RESPONSE TO OFFICE ACTION OF SEPTEMBER 8, 2005
Serial No. 10/524,332, page 6

Fig. 1a
PRIOR ART

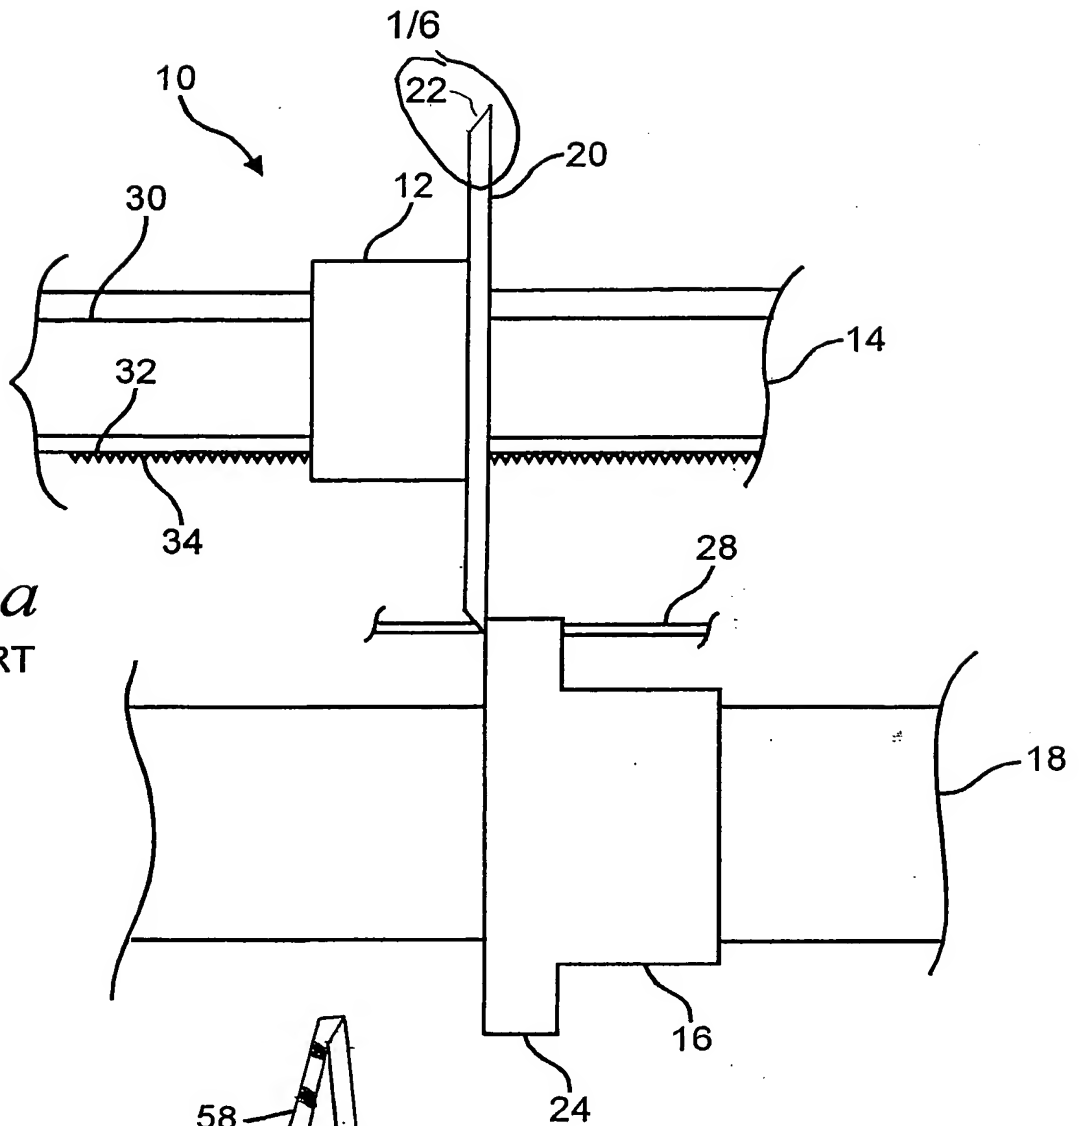
Finally, Applicant submits herewith inked drawing (all figures) to replace the original penciled drawing. Two inadvertent, but obvious errors have been corrected in FIGURE 1 (as marked in red). In FIGURE 1a, the blade 20 is symmetrical (as now shown) with respect to the rail 14. In FIGURE 1b, the cross-hatching of the slitter unit 24 has been corrected. Acceptance is respectfully requested.

Fig. 1b
PRIOR ART

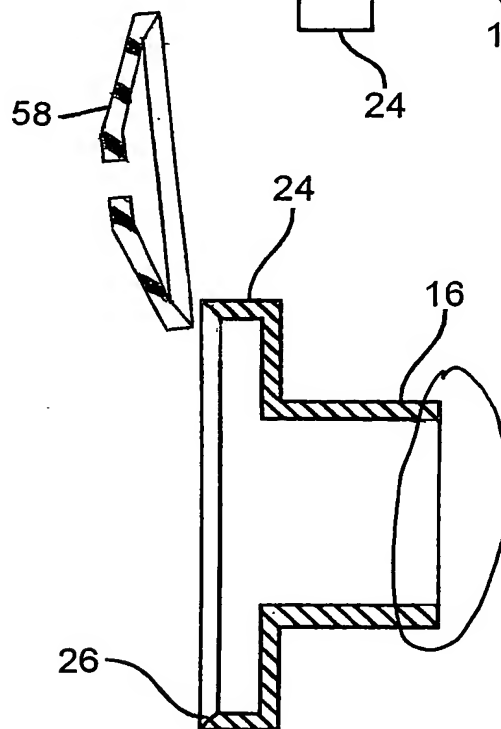
In the Office Action, the Examiner rejected this application on several grounds relating to the insufficiency of the disclosure. For example, the drawings were found objectionable for failing "to show the relationship between the guiding wheel (58) and the collar (24) as described in the specification." In a similar fashion, the Examiner objected to (i) the abstract; (ii) the specification; and (iii) the claims. Additionally, the Examiner rejected the claims under Section 112, second paragraph, for certain informalities.

To expedite prosecution, however, Applicant has amended FIGURE 1b to show the typical, conventional engagement of the cutter unit and guiding wheel, as requested by the Examiner. The description of that figure has also been amended to reflect the conventional nature of the engagement. Given these circumstances, no new matter is presented.
